October 5, 2005
Job 1663.01.01

RE: SUPPLEMENTAL GEOTECHNICAL PEER REVIEW
Slope Stability
Proposed Forest Green Estates, Tract 8268
Richmond, California

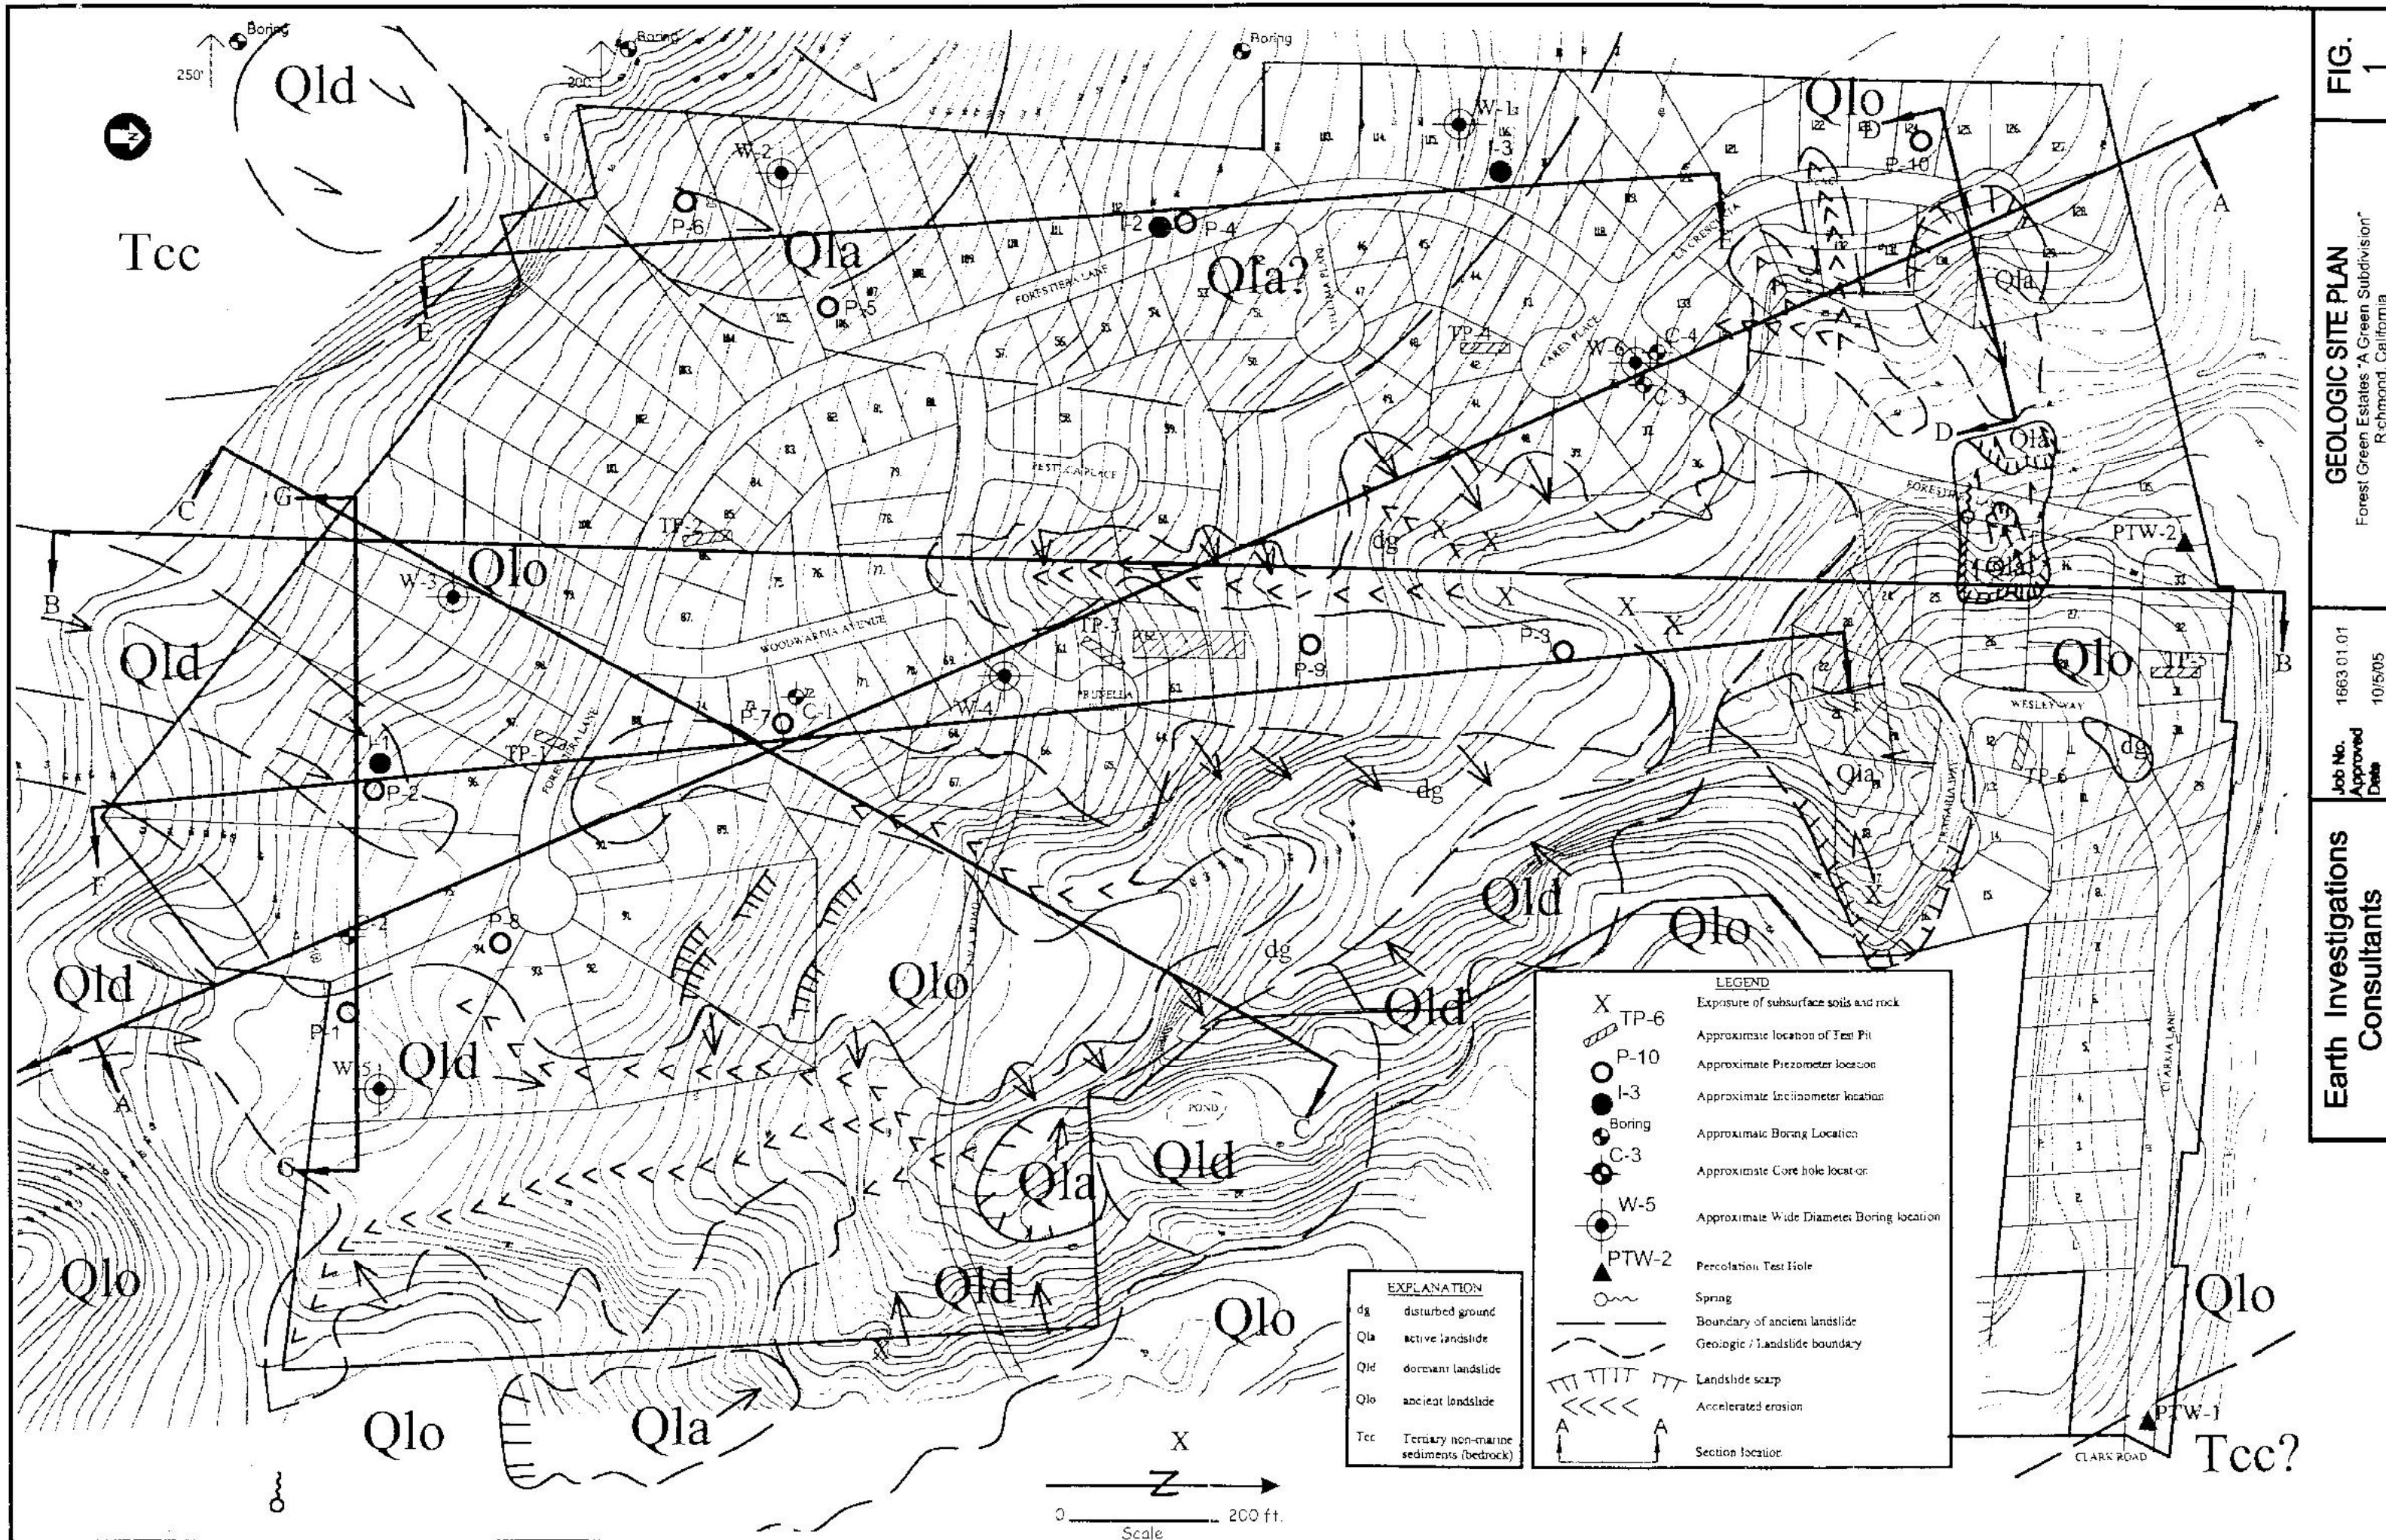
- Characterization of the site ground water and its potential impact to global stability in the southern and western parts of the site. This was to be accomplished by installation of a series 10, nested piezometers to a depth of 120 feet, and periodic reading, over a period of at least 1 average rainfall season (Figure 1, Geologic Site Plan);

- Analysis of deep-seated landslide creep reported in the western and south margins of the site (Terrasearch, Inc., 2003). This was to be accomplished by installation to a depth of up to 150 feet, and periodic reading of three (3) slope inclinometers over a period of 1 average rainfall season, and by (Figure 1). The inclinometers were also to be utilized for establishment of the supplemental ground water monitoring;

For additional stability across the western and south-central parts of the site, a 40-foot deep buttress is recommended (Figure 1), however, justification for the distribution and depth of buttressing is unclear. The distribution will be constrained by site boundaries and sensitive habitats. In an analysis of the walls of the buttress excavation, TI concludes a temporary 1H:1V slope is unstable, requiring excavation in 75-foot sections below a depth of 20 feet. The upper 20 feet can be mass graded.

To further assess active landsliding encroaching onto the western part of the site, TI drilled 3 borings on the adjacent Park Property (Figure 1; logs of borings not included in submittal). They conclude the borings confirm the presence of a large creeping landslide to depths of 60 to 65 feet, and of a smaller active landslide to a depth of 48 feet. Ground water was encountered at depths ranging from 25 to 40 feet, with perched water at 15 feet. Slope inclinometer data to confirm interpretation of landsliding and creep depths from the borings was not presented.

- We judge the evaluation of ground water elevations across the site reasonable. However, there are a few items that remain unknown:
 - Will it be acceptable to extend the hydraugers offsite as illustrated on Figure 1?

FIG. 2

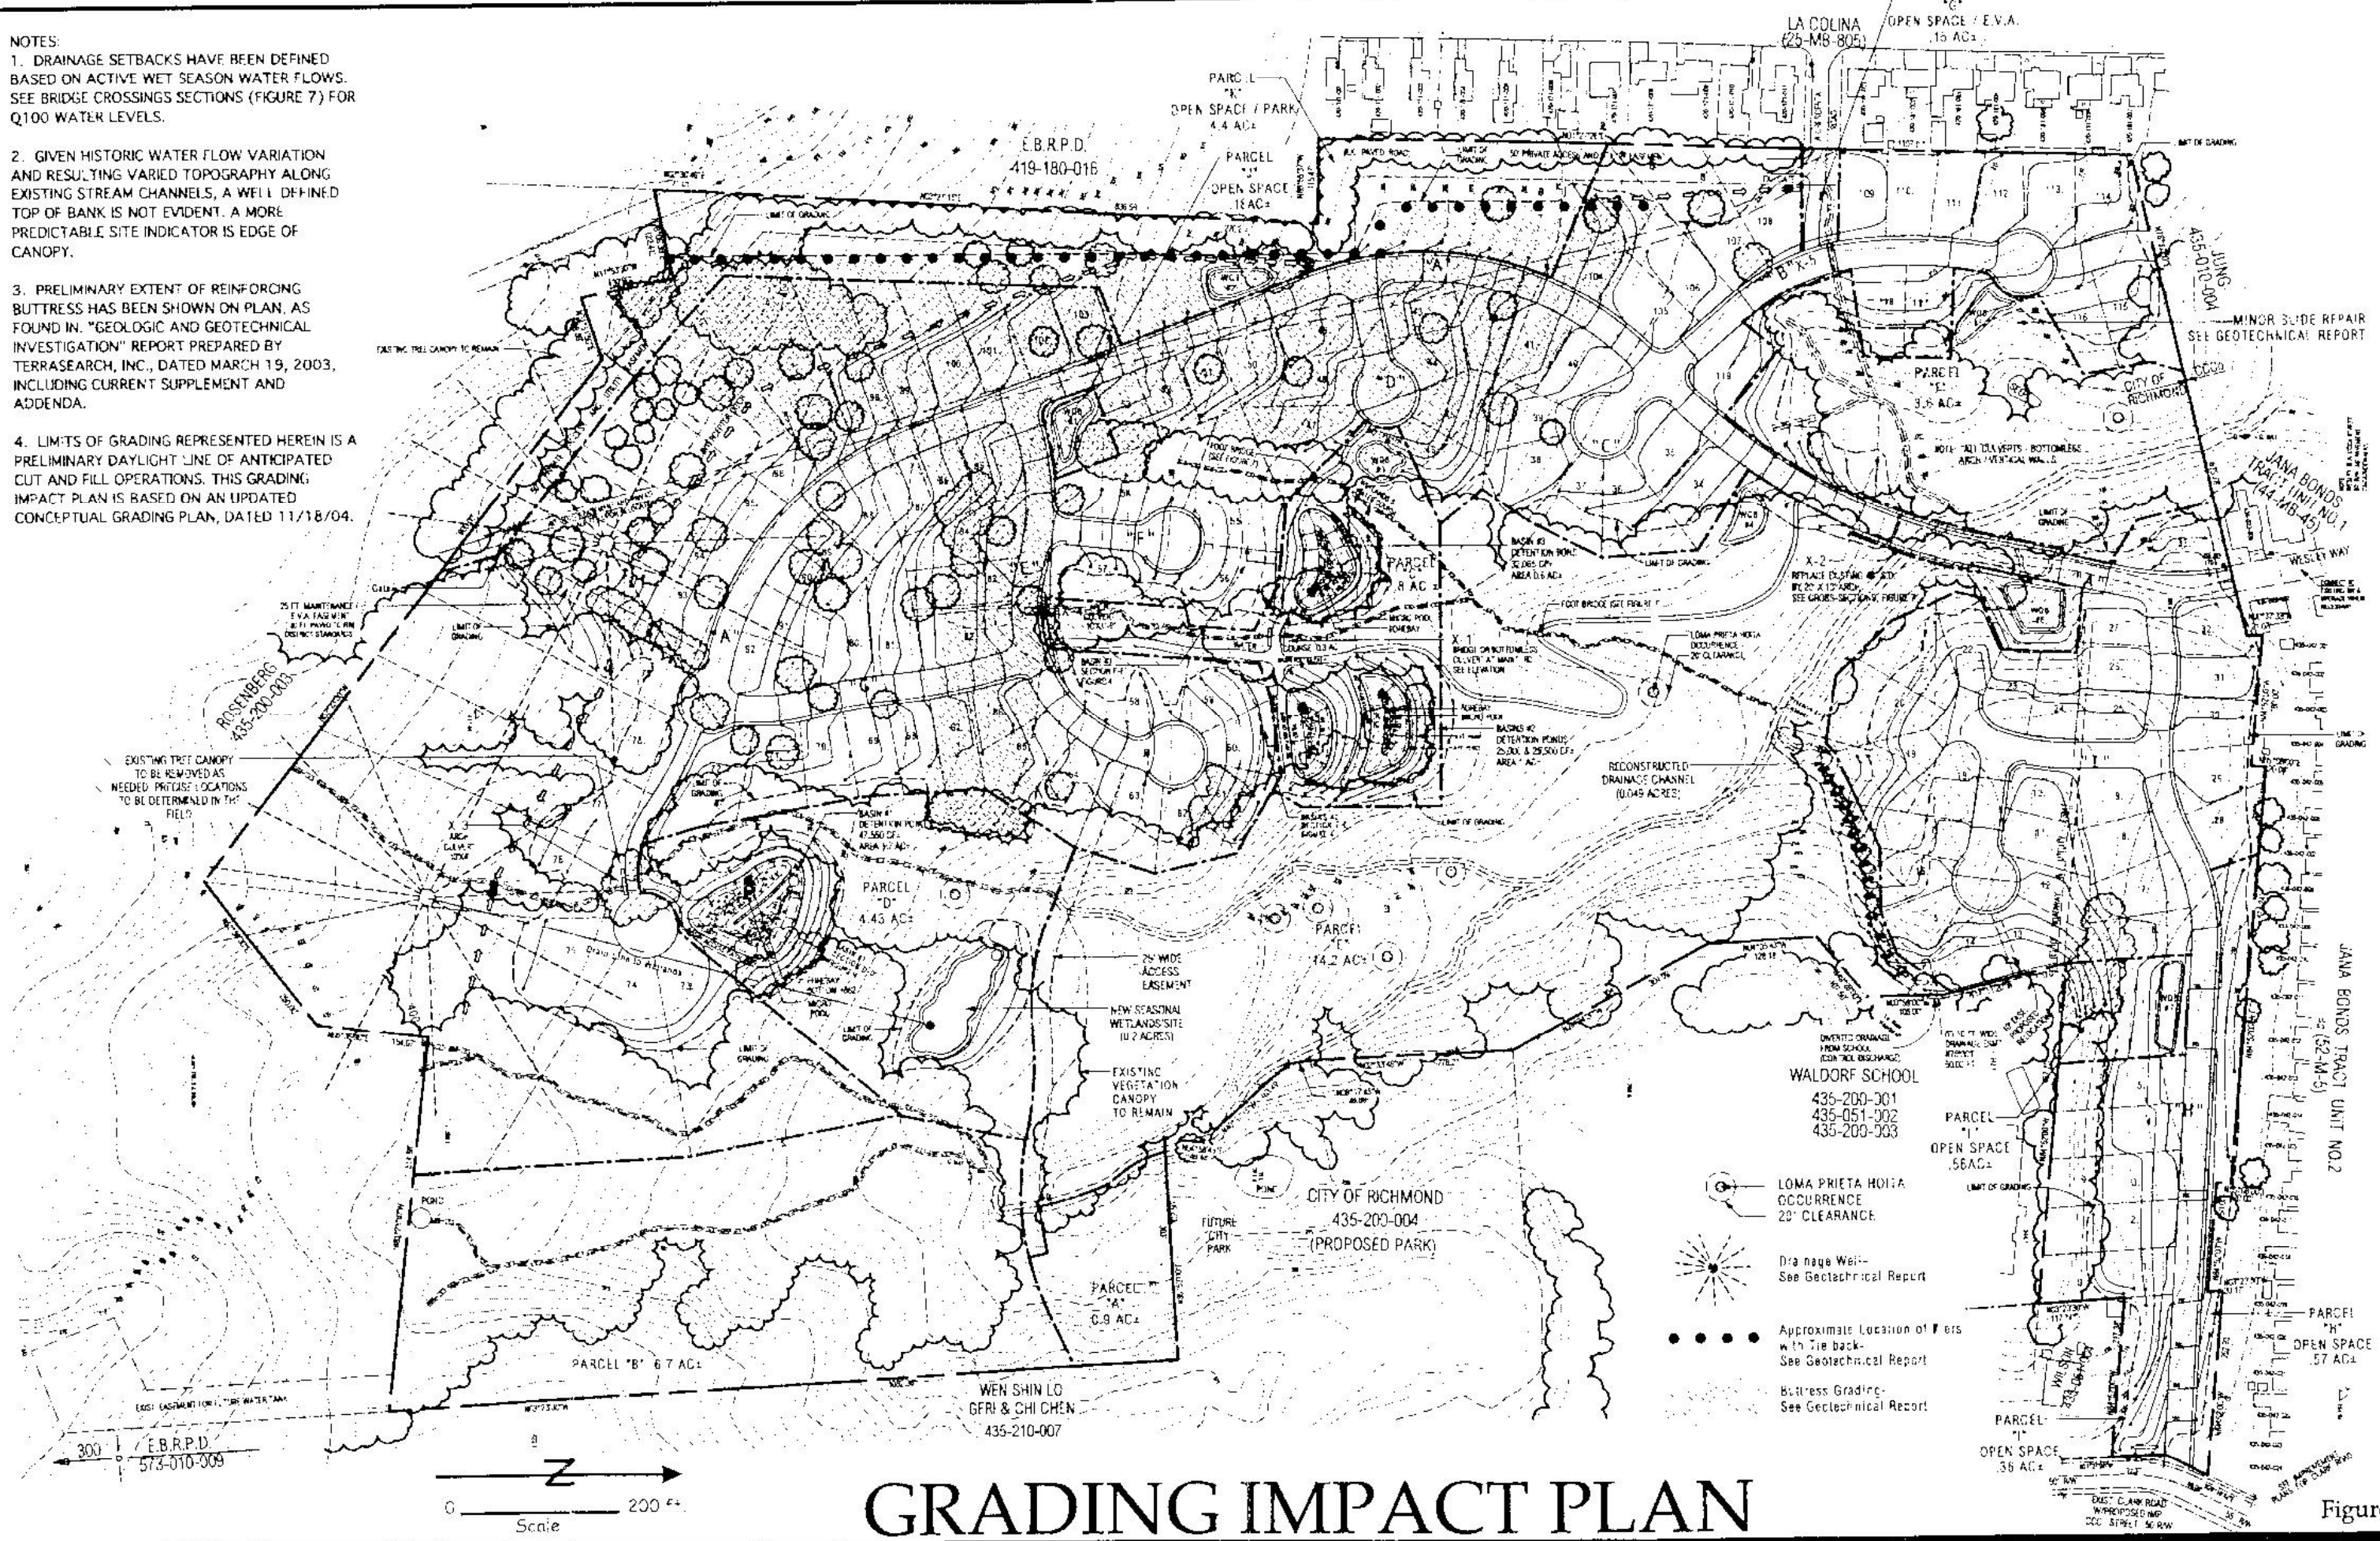
Given the potential impact to site stability, TI recommends control of ground water by a scheme presented by Drilltech Drilling and Shoring (2005). The creative ground water withdrawal system involves drilling 2, 25- to 30-foot diameter shafts to a depth of 120 feet in the southern part of the site (Figure 2). A series of 300-foot long, horizontal drains (hydraugers) will be arranged in a radial pattern from varying elevations of each shaft wall to intercept ground water. The shaft will be designed as a sump to collect the water from the hydraugers. Accumulated water would either be pumped to a storm drainage facility, such as a seasonal wetland, or drained by gravity to an onsite swale, which, given the terrain would probably be in the middle of the site.

- The direction and approximate location of the tiebacks should be illustrated. It is usually necessary to secure permission for offsite improvements;
- Drilltech indicates the piers will extend below the slide surface encroaching into the western part of the site. What depth is the target slide surface?
- Presumably there will a buried wall or grade beam associated with the retention system. How will the buried element(s) be drained?
- The proposed stockpile distribution and thickness should be evaluated and illustrated on the Grading Impact Plan.
